# **HATFIELD BOROUGH PLANNING COMMISSION**

**June 14, 2021**

### 3. 43 Roosevelt Final Land Development Presentation:

## 4. Bennett's Court Preliminary Land Development Presentation:

**PROPOSED ELECTRICAL SITE PLAN**  
SCALE: 1"=20'-0"

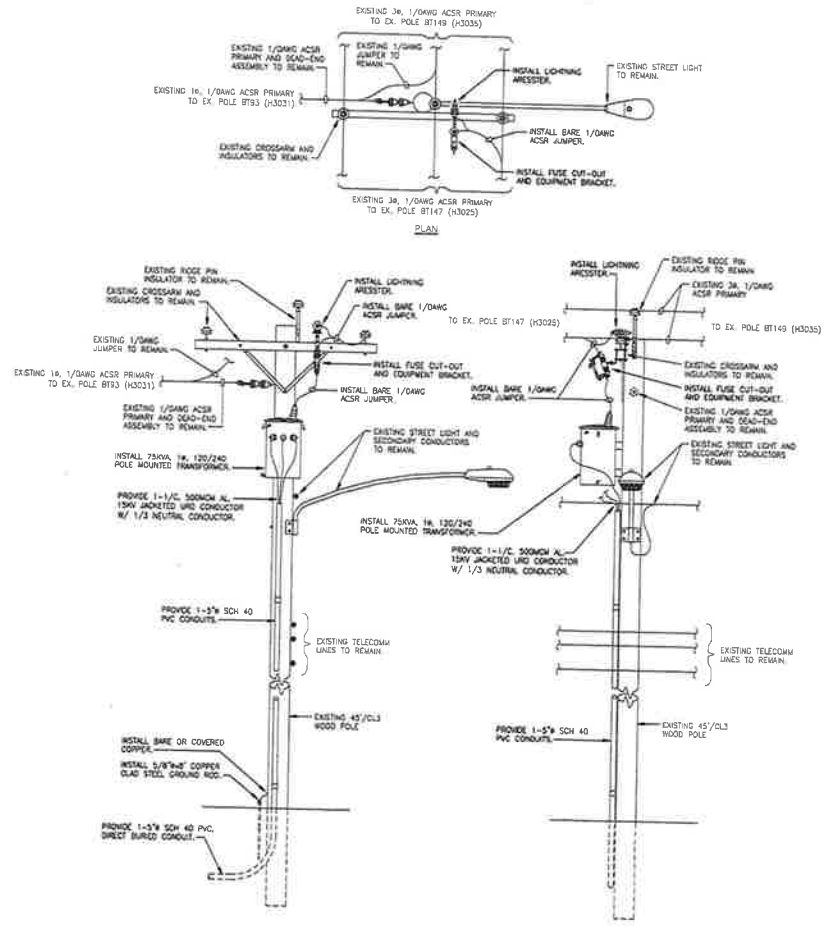
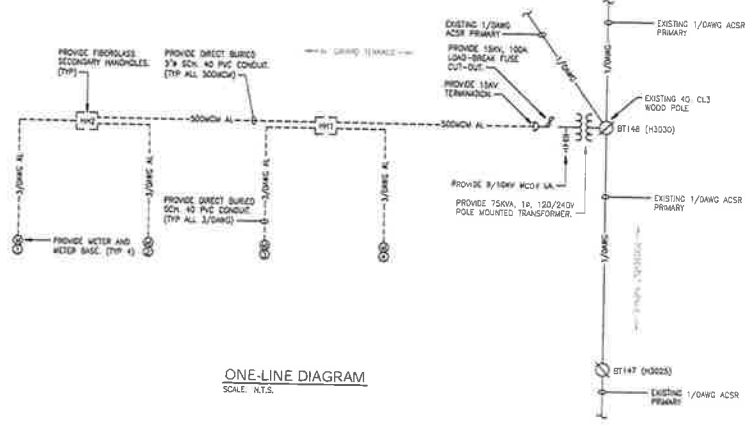
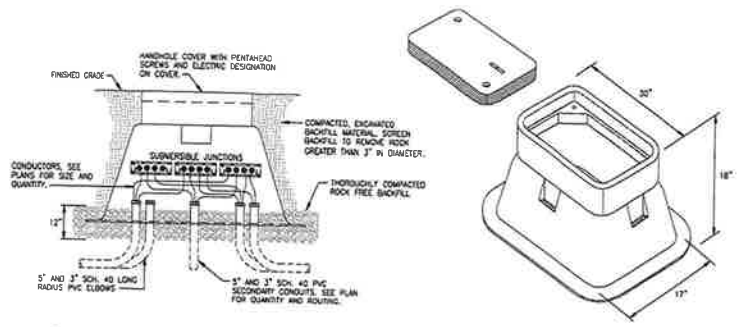
The submitted Land Development Plans from Lenape Valley Engineering, do not include or indicate electric services to the 4 proposed lots. The layout, configuration and location of the electric services to the residential units are the responsibility of the Borough of Hatfield. It is the Developer's responsibility to include the electric services as part of the overall project. The Developer shall install and pay for the electric services in accordance with the Borough's requirements and layout. The attached electric service plan and details are to be included on future plan submissions.

Based on our review, the Developer shall include the electric services to the townhouses on all future plans.
